Certified Action of the City of Raleigh Planning Commission

Case File / Name: SP-18-12 / Sheetz at Millbrook

Nature of Case: The request is to approve a 6,489 square feet convenience store/eating establishment with drive-thru and 6 gas islands under a canopy located on a 2.646 acre site, zoned Neighborhood Business CUD.

SUBJECT: SP-18-12 / Sheetz at Millbrook

SP-18-12 Sheetz at Millbrook – Site Plan

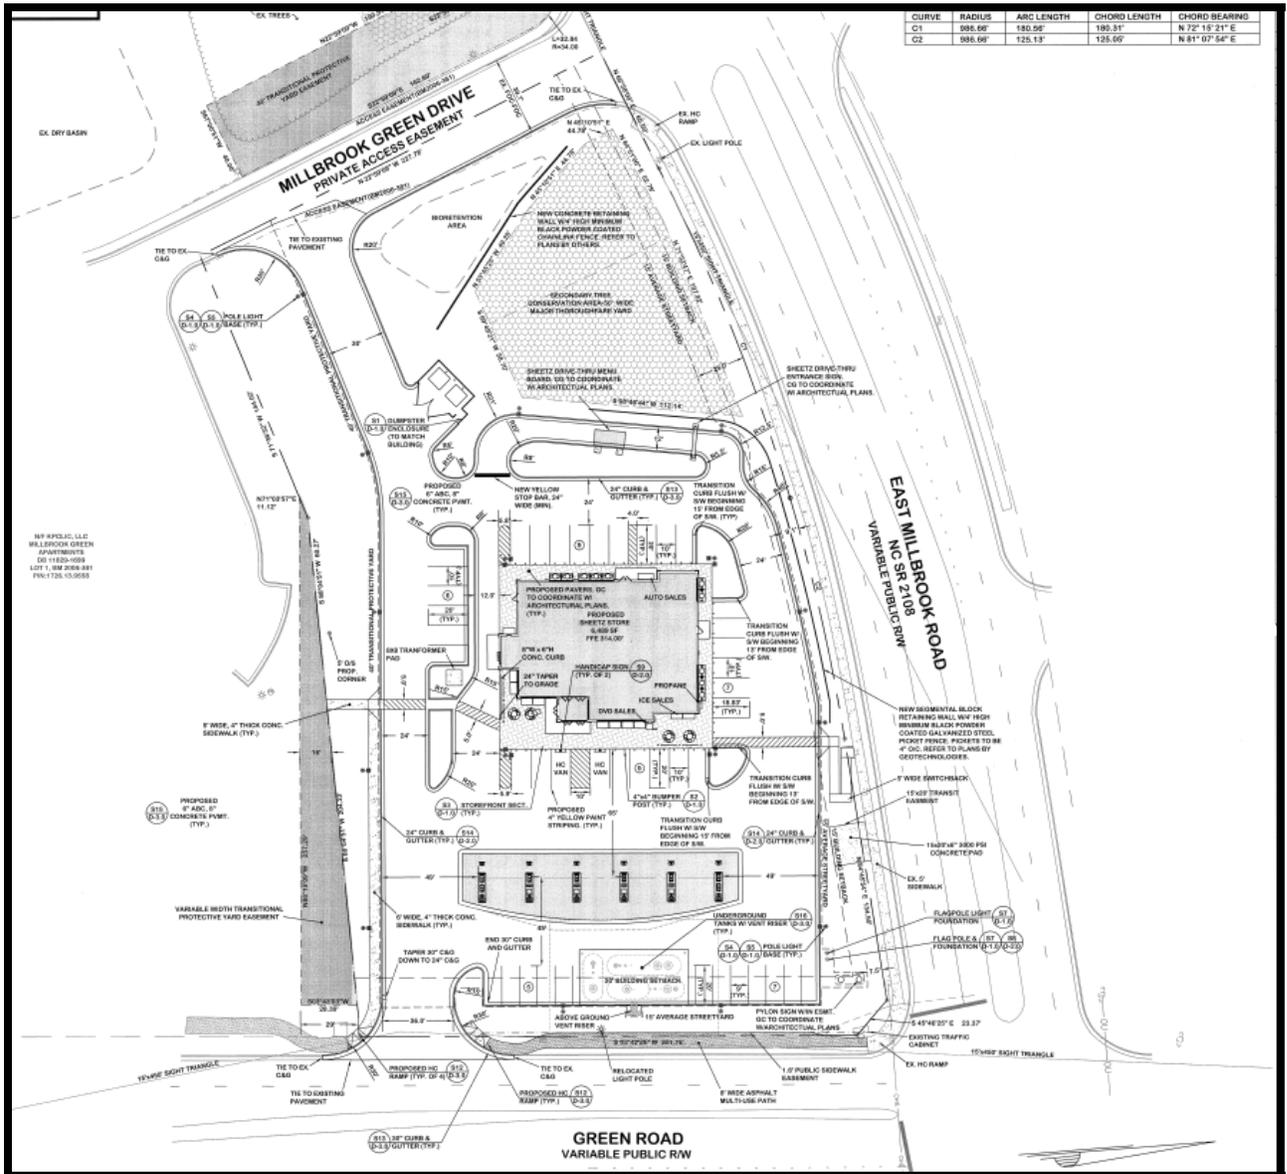
- (1) That three Inverted U bicycle racks are added to the site plan;

<u>Comment</u>	<u>Response</u>
Create/ expand sidewalk area at northeast corner of building to provide additional outdoor dining space and a more inviting arrival for pedestrians walking from E. Millbrook Road [commensurate with Code Sec. 10-2132.2(d)(1)(d)].	Applicant will provide a more appealing pedestrian experience by providing 5 tables w/ awnings along the northern side of the building.
Given visibility of north elevation to street (and pedestrian access there), break up expanse of wall: more vertical articulation; add actual windows; wrap an awning around NE corner of building to cover partially an expanded outdoor dining area [commensurate with Code Sec. 10-2132.2(d)(1)(k)].	Applicant provided articulation to the northern elevation and added awnings over the service door and "faux windows."
Diversify plant selections in transitional protective yard to create more of native woodland feel [commensurate with Code Sec. 10-2132.2(d)(1)(k)].	Applicant diversified the plant selections as requested.
